SITE DATA:

EXISTING ZONING: R-1 (SOUTHWEST PIECE IS ZONED R-1 RURAL)
 COMP PLAN: LOW DENSITY RESIDENTIAL 4 UNITS/ACRE (SOUTHWEST PIECE IS GUIDED RURAL)
 PROPOSED ZONING: PUD

PROPOSED LOTS: 343
 75': 119
 65': 121
 55': 103

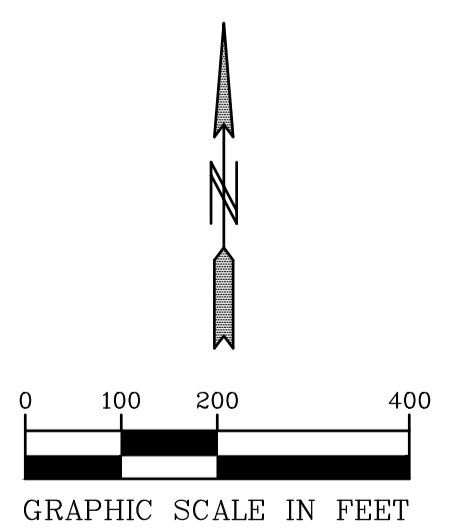
If possible connecting these cul-de-sacs. CDS are higher maintenance for the City, particularly with plowing.

The City is planning to extend trunk watermain up Variolite, to loop with the trunk watermain on CSAH 5. We will have to discuss where this trunk WM connects.

Most likely a right turn lane will be required off of Variolite Street.

City is currently designing a reconstruction of Variolite Street, this is planned for this summer. Ideally any units built would not be reliant on Variolite Street for access.

CDS need to have a 50' radius to back of curb.
Engineering Design Standards are available on the City Website Engineering Department Page.

This would require a temporary cul-de-sac. The area of the temporary cul-de-sac will require at a minimum roadway easement for the cds and snow storage.

The City is part of the Lower Rum River WMO, and all WMO requirements must be met. Contact Engineering Department with questions.

Could this be adjusted to be a small loop, or just one CDS?

Is this street going to be curb & gutter, or drainage ditches?

This must be a permanent Cul-de-Sac with proper setbacks. If the parcel to the north develops and the road is extended, pavement can be removed and the right of way reduced to follow the curb.

Half cul-de-sacs and temporary cul-de-sacs have not worked well in Ramsey.

A wetland delineation will be required. Mitigation may be required if the pond will impact the function of this wetland.

This project crosses the threshold for environmental documentaion. The project scheduile must include time for preparation of the environmental document and review by the appropriate agencies.

The City does not accept wetlands for park dedication credit. Creditable park dedication must be upland area outside of wetlands.

This plat will require review by Anoka County Highway department.

Turn lanes and bypass lanes will most likely be required.

A sanitary sewer stub was provided south of Trott Brook. The stub and lift station down stream may not provide adequate capacity for this development.

The City is requiring construction of a lift station in the southwest corner of this project to serve the site. The City will be extending gravity sewer up Variolite Street to just south of Trott Brook in 2020. This lift station will connect to that gravity line.

All stormwater ponds must have a maintenance access covered by drainage and utility easement.

This surface should be vegetated with slopes gentle enough for equipment access. Lot spacing must be adjusted to provide this required access route.

Stormwater Design must meet Lower Rum River Watershed Management Organization requirements.

Compliance with infiltration must be demonstrated using the MIDS calculator from the MPCA, P-8 or Win-SLAMM software. Printouts provided must include data input and results including removal efficiencies.

16.5 foot d/u easement required from edge of delineated wetland, no ponds in that area.
